Access Compliance Report

Public Rights-of-Way

Intersection ID: 51478	Main Street: BENDERLOCH_DR	Cross Street: MEADOW_BOTTOM_RD	Location: S
ADA ID: E3D84BD62E0B	Ramp Type: PerpDiag	Initial Pass/Fail: Fail	Overall Compliance: No
Severity Score: 12.5			
Codes/Mitigation Info/Possible Solution		Field Measurements/Component Compliance

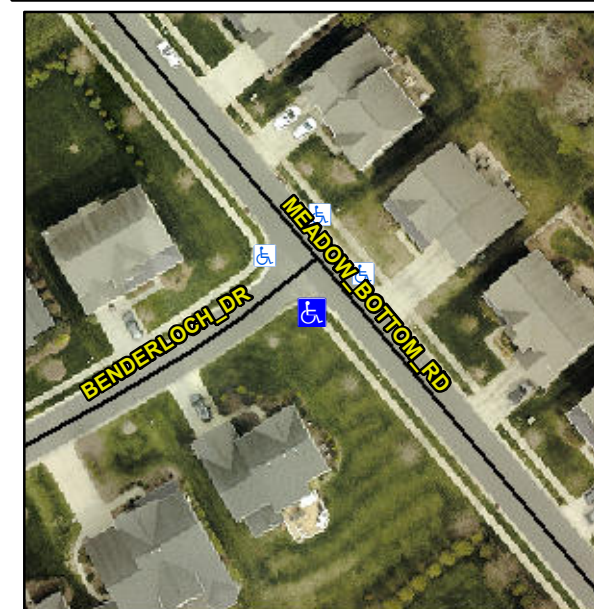
Not Found, R304.5.3

Remove & Replace Curb Ramp With Two New Directional Ramps or Equivalent.
